**2025/0121 - GATEWAY 36 PLOT 7, LAND SOUTH OF DEARNE VALLEY PARKWAY HOYLAND
RESPONSE TO DESIGN, LANDSCAPE AND VISUAL IMPACT COMMENTS**

Thank you for your email of 30 October 2025 including the comments of your urban design officer and landscape consultant on the above reserved matters application for an employment building (amended proposal).

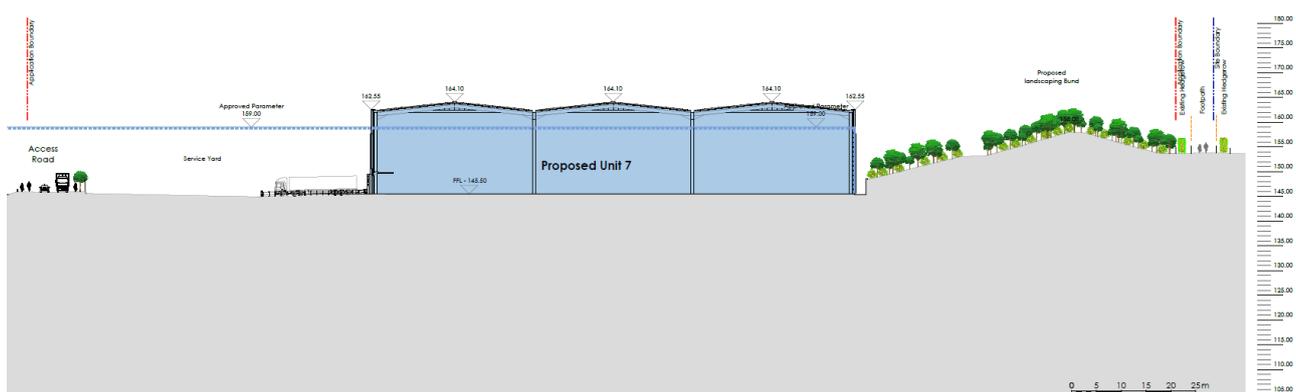
Our revised reserved matters submission included three site section drawings prepared by the architect. Section 2¹ shows the relationship of the proposed building with land to the southeast (i.e. the boundary of the housing allocation site). See extract image below, whereby the housing allocation site would be to the right hand side beyond the proposed landscape bund and footpath:

This demonstrates the height and ground level of the building relative to the adjacent landform and landscaped area, indicating the building to be substantially screened along this line.

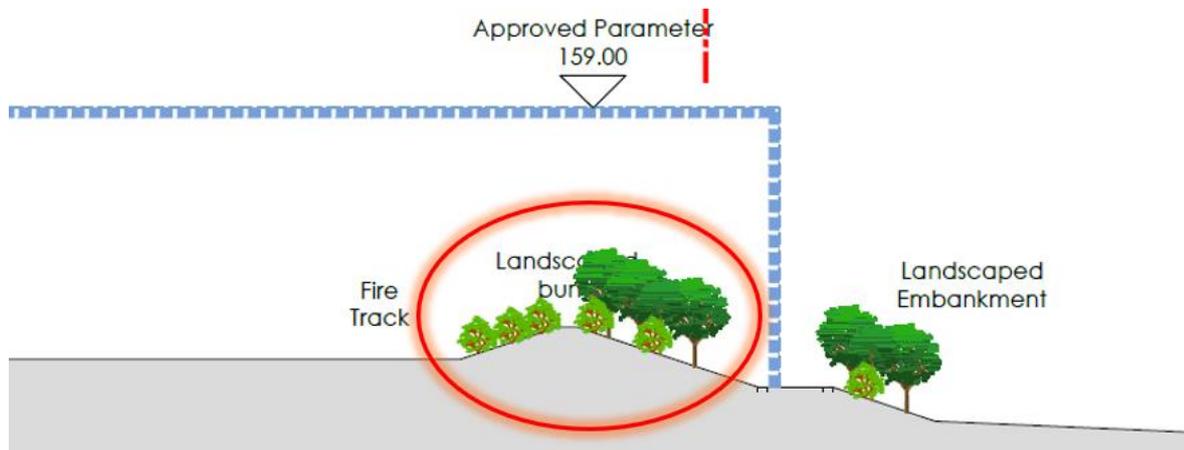
The Urban Design Officer's comments refer to the description in the Design & Access Statement³ (DAS) of tree planting proposed towards the top of the slopes *below* the development plateau. Whilst woodland planting is proposed as described, this is not the sole location of the woodland planting. An additional wooded landscape bund is proposed on the development plateau at its southwest aspect.

This bund is shown on the External Levels Overall Plan⁴ and the Section 6 drawing⁵ (see extract below), which demonstrates it to be approximately 15m wide and to elevate planting above the plateau level. The Landscape Planting Plan⁶ confirms it is to be planted as mixed native woodland.

SECTION BB'
 through Unit 7 and Hoyland North
 Masterplan Framework Cricket
 Pitch

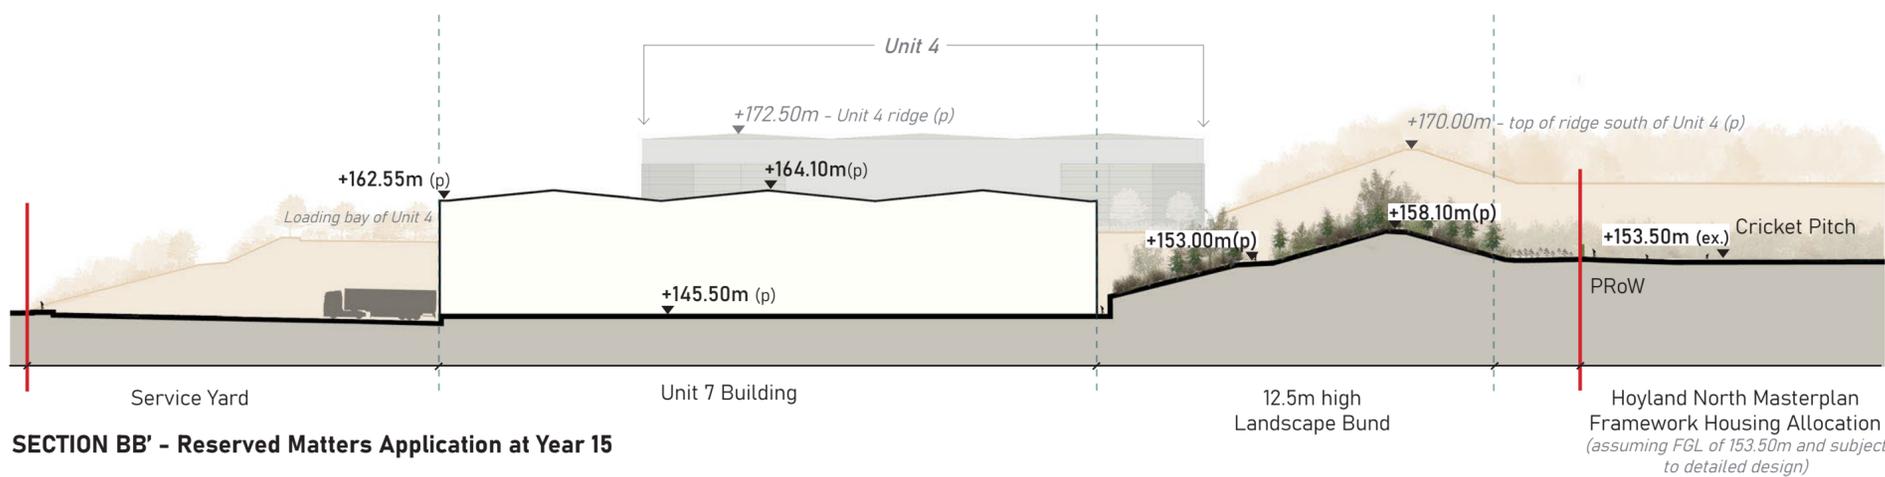
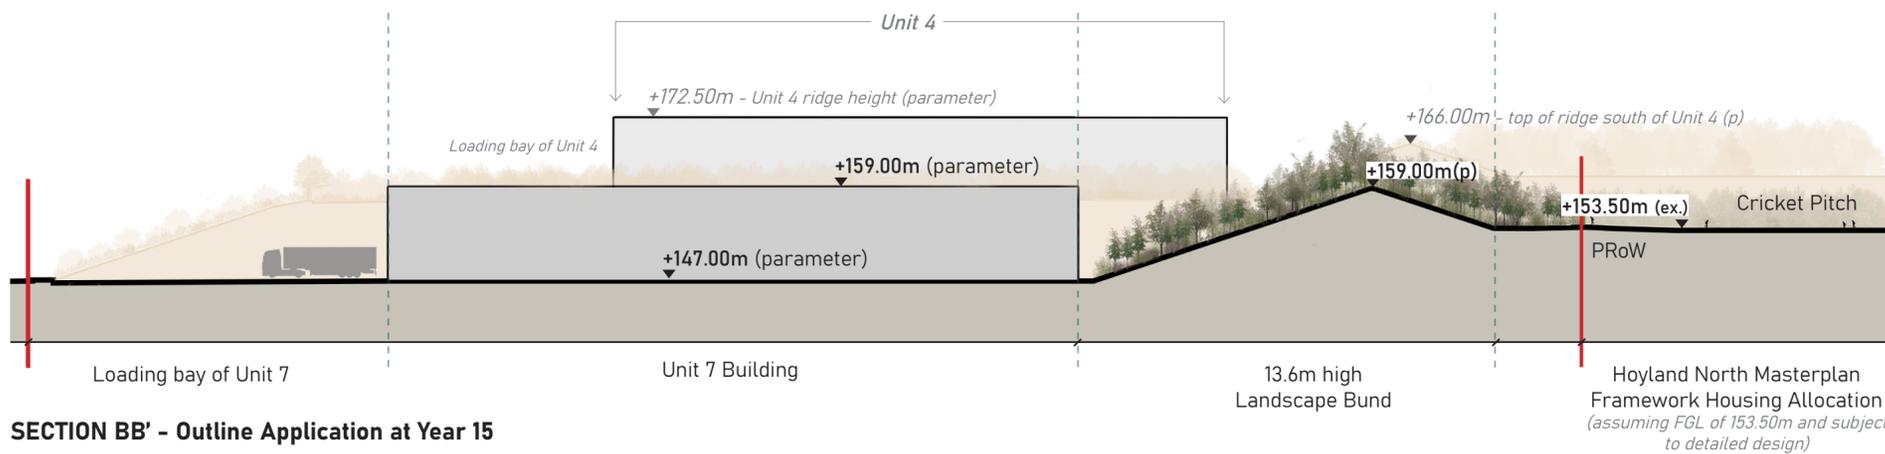
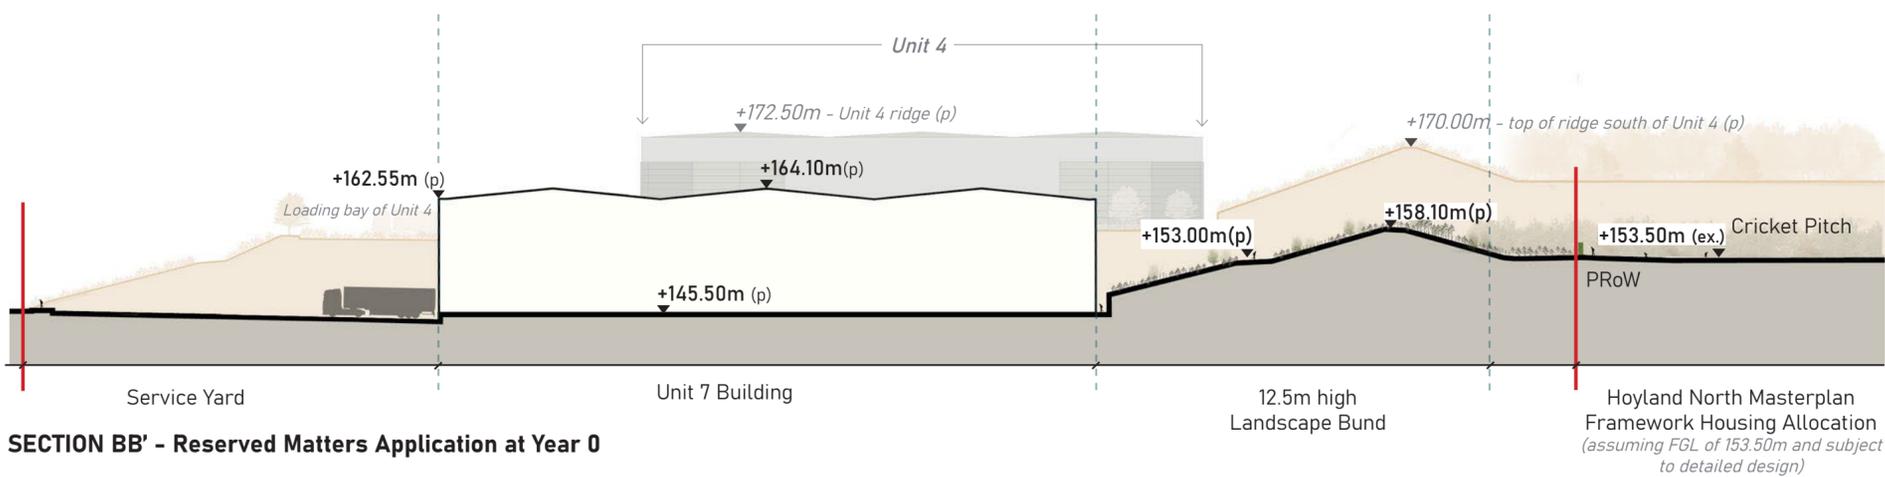
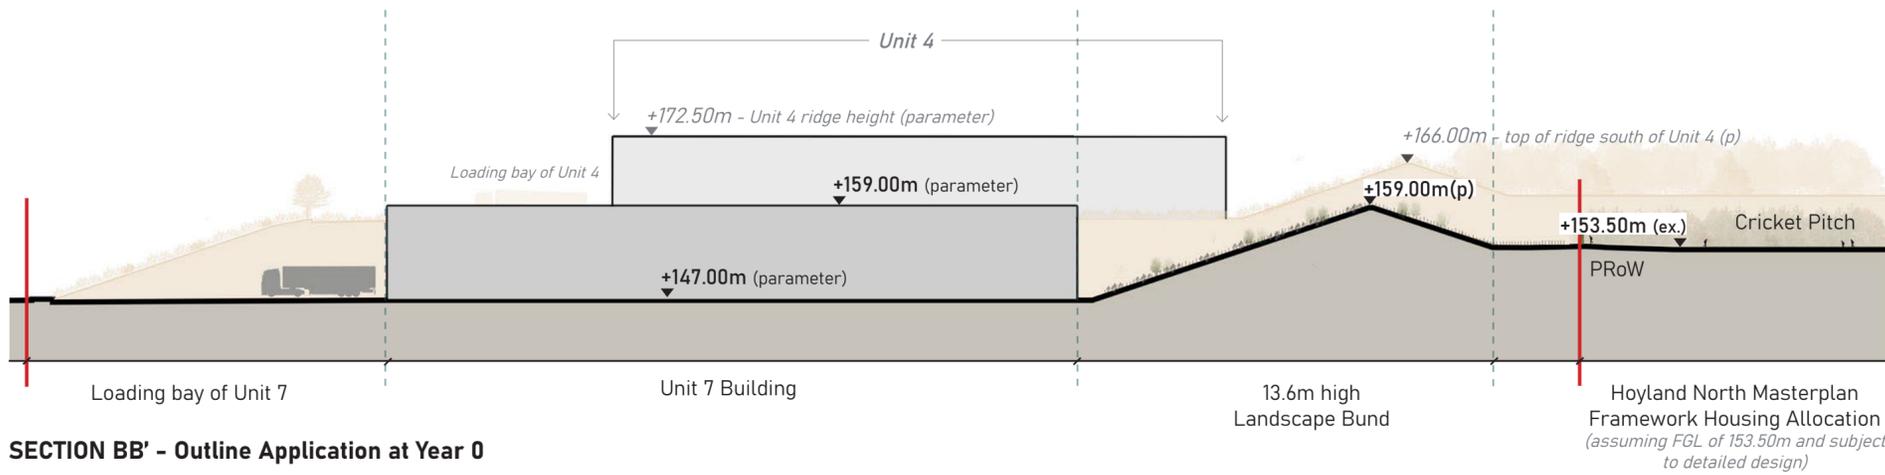
As requested, we respond to the comments of the Urban Design Officer including those relating to any effect of the development on the adjacent land allocated for housing development.

We note that these section lines do not capture the adjacent housing allocation site, but also that the details of the housing scheme are not known (i.e. ground levels, retained/proposed landscape buffers, arrangement and orientation of dwellings and open space).

Section BB corresponds to Section 2 and shows the relationship between the proposed Unit 7 building and the adjacent housing allocation site in the location of the open space (cricket pitch) as shown on the Hoyland North Masterplan Framework drawing.

In both cases, the same section line is presented with outline parameter data and the reserved matters proposal, both at Year 0 and Year 15. This allows comparison with the original approved extent and shows the effect of mature landscape planting.

Whilst there may be visibility of the employment development from the housing allocation site (which is not unusual), taken with the landscape bund and planting proposed within the employment site (and notwithstanding landscape planting that may reasonably be expected in the housing site), this is not considered to prejudice the setting of future housing or constitute a harmful impact.
